Office of  
Environment  
& Heritage

DOC18/692798  
SSD 8790

**Exhibition of Alterations and Additions to Parramatta West Public School - Auburn and Young Street, Parramatta (SSD 8790)**

## **Attachment 1 – OEH comments on Exhibition of Alterations and Additions to Parramatta West Public School at Auburn and Young Street, Parramatta (SSD 8790)**

Figure 1: 1943 aerial photograph of the subject site (with heavy outline) and its surrounding context. Note that building E (administration) and building F (general learning) are visible. (Source: NSW Gov.)

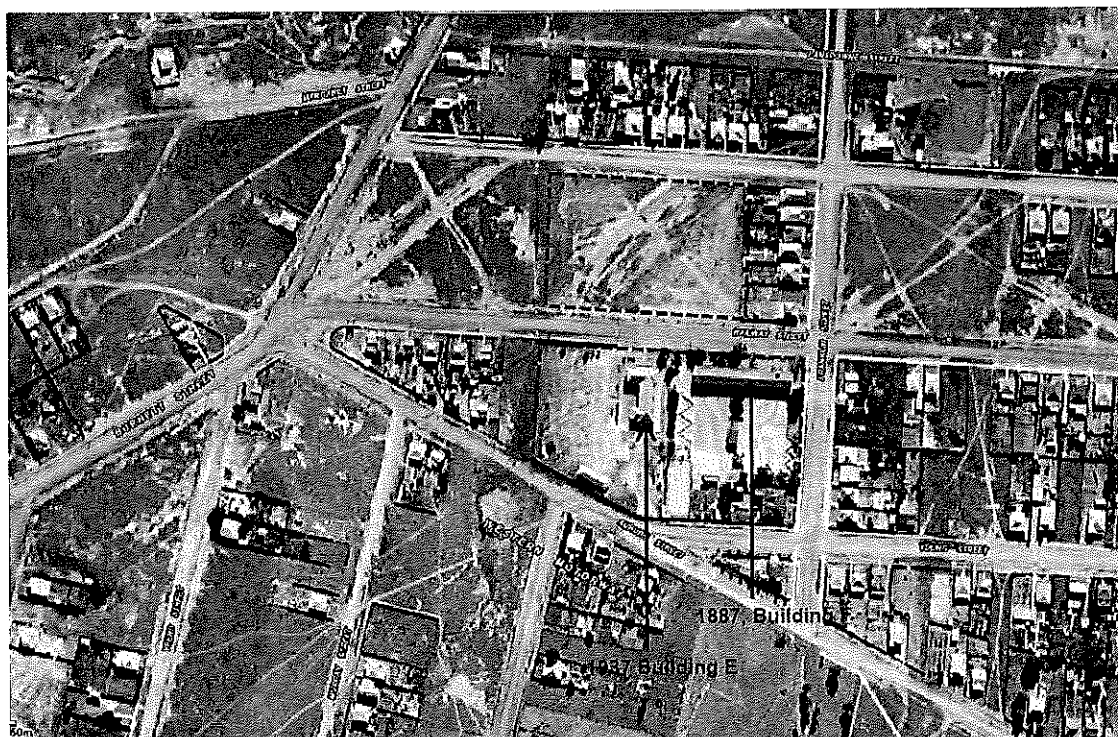
OEH notes that the SEARs did not require the preparation of an Aboriginal Cultural Heritage Assessment (ACHAR) or consultation as required by OEH guidelines. It is noted that the proposed new buildings on the northern side of Railway Street on Burra Reserve involve excavation into the natural ground level as shown on *Figure 26: Proposed east elevation of the new school building*. Burra Reserve which is part of the project site is currently grassed. The Statement of Heritage Impact prepared by Conrad Gargett dated June 2018 includes aerial photography from 1943 (Figure 1 below) that show the site as being vacant of structures. Given this, the site may contain the presence of Aboriginal Cultural Heritage, however no assessment has been undertaken of the site.

Without any archaeological testing it is not possible to exclude the presence of sub-surface artefacts across the site, including under existing buildings where no basement exists. OEH notes that the proposal requires excavation that may impact on sub-surface Aboriginal objects if present. As such OEH preference is for the preparation of an Aboriginal Cultural Heritage Assessment Report (ACHAR). The ACHAR is to identify, describe and document the Aboriginal cultural heritage values that exist across the whole area that will be affected by the development. This may include the need for surface survey and test excavation. The identification of cultural heritage values must be conducted in accordance with the Code of Practice for Archaeological Investigations of Aboriginal Objects in NSW (OEH 2010), and be guided by the *Guide to investigating, assessing and reporting on Aboriginal Cultural Heritage in NSW* (DECCW, 2011).

Further, consultation with Aboriginal people must be undertaken and documented in accordance with the *Aboriginal cultural heritage consultation requirements for proponents 2010* (DECCW). The significance of cultural heritage values for Aboriginal people who have a cultural association with the land must be documented in the ACHAR.
